**National Committee on Uniform Traffic Control Devices**  
TECHNICAL COMMITTEE RECOMMENDATIONS TO NCUTCD COUNCIL

**TECHNICAL COMMITTEE: Regulatory/Warning Signs Technical Committee**

**TOPIC: Warning Signs, Two-way Traffic on a Three Lane Road**

**AFFECTED PORTIONS OF MUTCD: Sections 2C.XX, Table 2C-1; Table 2C-21; Figure 2C-6**

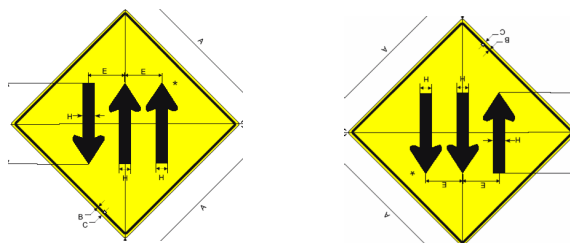
The *Synthesis of Non-MUTCD Signing* identified seventy-four signs or categories of signs that are not in the MUTCD but were in common use by various States, local governments and Canada. The *Synthesis of Non-MUTCD Signing* recommended that these signs be considered for inclusion in the NCUTCD. One of these signs was the symbol “Two-way Traffic on a Three Lane Road” shown below.

At least 3 States are using a variant of the W6-~~13~~ two-way traffic symbol for warning of two-way traffic on roads having three lanes, with one lane in one direction and two lanes in the other direction. The standard W6-~~13~~ symbol shows one up arrow and one down arrow. The three States’ variants show three arrows, symbolically denoting not only two-way traffic but also how many lanes in each direction. The Canadian equivalent of the W6-~~13~~ symbol includes a vertical broken line separating the up and down arrows, and one State’s 3-arrow variant uses the same concept (but with a solid line) to reinforce the message.

Recommendation: This type of sign with 3 arrows (2 up/1 down or 1 up/2 down) should be considered for addition to the MUTCD, for use on 3-lane undivided roads only.

**Add Section 2C.XX, and add sign shown above to Table 2C-1, Table 2C-2 and Figure 2C-6**

**Section 2C.XX Two-way Traffic on a Three Lane Roadway (W6-X) sign**

The Two-way Traffic on a Three Lane Roadway (W6-Xa and W6-Xb) signs may be installed ~~in advance of and at intervals~~ along three lane roadways with two lanes in one direction and one in the opposing direction.

~~Where used, t~~ **The W6-X sign shall match the lane configuration of the roadway.**
